**RE: Champion Xpress Car Wash
1520 Juan Tabo Blvd. NE
Grading and Drainage Plan
Engineer's Stamp Date: 11/03/21
Hydrology File: J22D031**

Based upon the information provided in your submittal received 11/03/2021, the Grading & Drainage Plan is **not** approved for Building Permit, SO-19 Permit, and for action by the DRB on Site Plan for Building Permit. The following comments need to be addressed for approval of the above referenced project:

SHEET C3.0

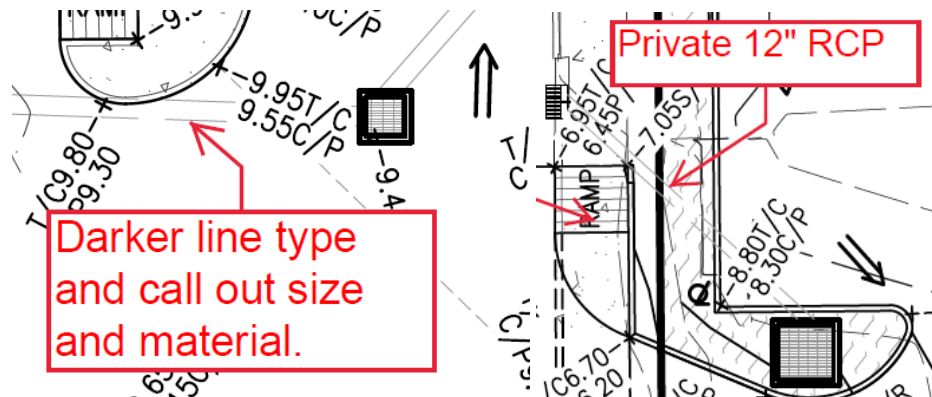
1. Update contact information for Water Authority. I am no longer with Water Authority.

No longer @ Water
Authority.

2. Verify grate elevations as they should work with the drainage structure and not flow out of the grate in the event it exceeds the weir elevation.
3. Call out proposed pipe sections and materials and please change line type to make them bold and pop out. Please note/label "private" ownership and maintenance on private infrastructure.

4. Provide existing top of pipe elevation at Juan Tabo and provide proposed top of pipe elevations.
5. Please include existing flow line elevations at Juan Tabo.
- 6.

SHEET C3.1

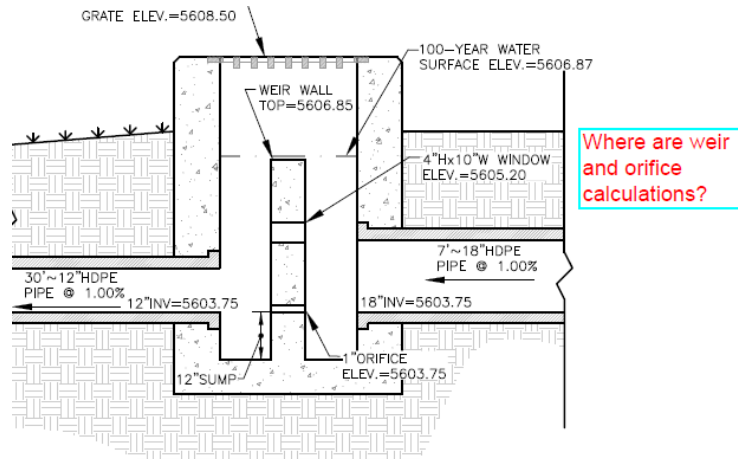
1. Please provide the weir calculations, per DPM Article 6-16(A), for the curb cuts and sidewalk culverts. A coefficient of 2.7 is typically used for the weir equation $Q = CLH^{2/3}$.
2. The proposed entrances need to follow standard details. Please see CoA Standard Detail 2426. Check with Transportation.
3. Please update the SO-19 Notes. See Attachment.
4. Update reference to updated DPM and go over calculations as details have changed in the new DPM. Ensure numbers are updated in the associated tables and information based on new DPM values.

Need to utilize new
DPM 6-2-A

- b. Please use the procedure for 40 acre and smaller basins as outlined in Development Process Manual (DPM) (signed 06/08/20) Article 6-2(a). Please provide both the existing conditions and proposed conditions for the 100 year-6 hour storm event.
5. Include details of the outfall structure at the pond.
6. Include details of all the inlets at grates. What Type? Standards?
7. Please utilize RCP for the section of pipe connecting to Juan Tabo Blvd. HDPE for the remaining sections is fine.
8. Refer to previous/existing G&D for the site and call out 20% Free Discharge and follow that information.
9. A water block, 0.87' high, per COA Paving Detail No. 2426, is required at the driveway entrances. Please utilize this detail for the entrances.

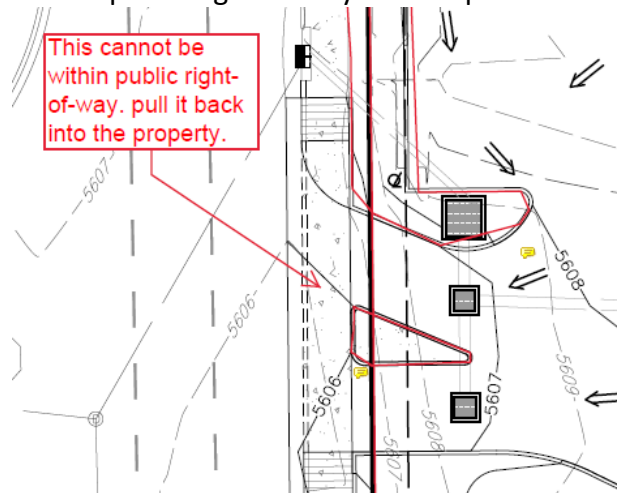
10. Please add a note under Grading Notes. "Side slopes need to be stabilized with Native Grass Seed (per City Spec 1012) with Aggregate Mulch or equal (Must satisfy the "Final Stabilization criteria" CGP 2.2.14.b.)".
11. Provide a detail of the pond including property line, inlet and to include volume and max water elevation.
12. Include weir and orifice calcs.

13. Consider removing the median at the entrance. If it is to remain, please remove the portion within public right-of-way and keep this within the property.
